SERVICE INFORMATION NO. SI D4-181

Andair Fuel valve system with extension

SERVICE ALERT

Issued 12th June 2015

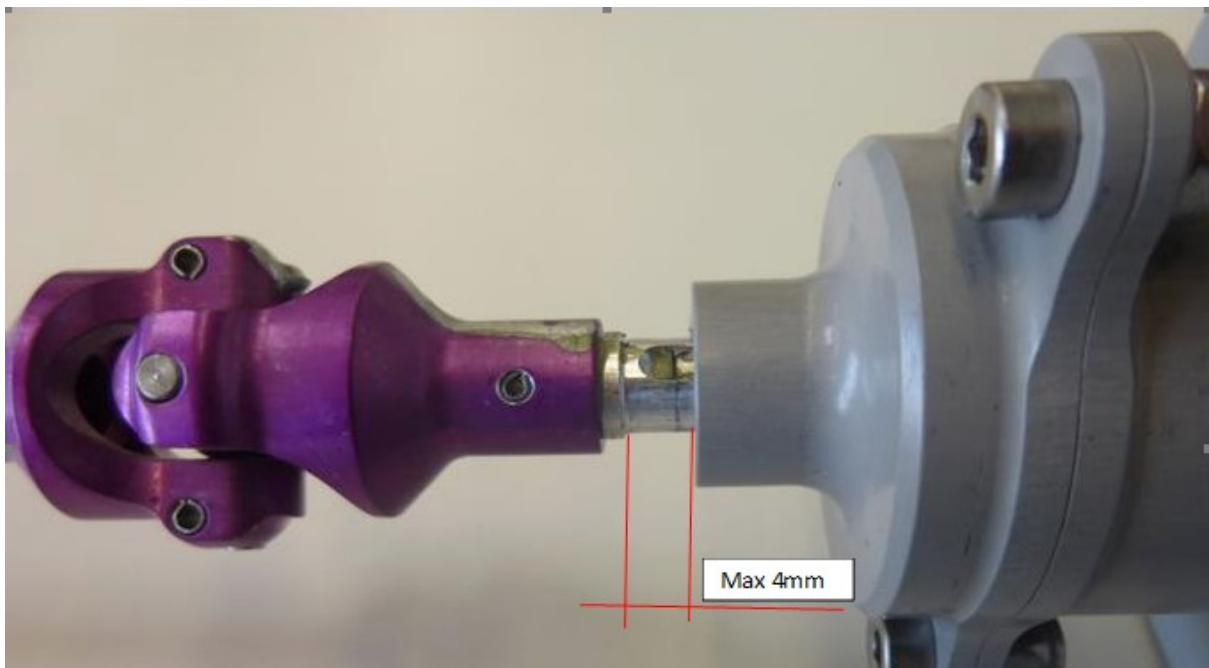
This Service alert applies to all Diamond Aircraft fitted with this extension system. It has been brought to our attention that there could be a possible lack of engagement between the universal joint assembly and the top of the valve assembly. It is requested that a check be carried out to establish a minimum of engagement of 5mm with the dowel in the valve assembly. The picture below gives a maximum dimension of 4mm. Less than this can be considered satisfactory, this gives over 5mm engagement. Greater than this, the assembly should be investigated further and a new longer dowel be fitted. The longer dowels can be supplied.
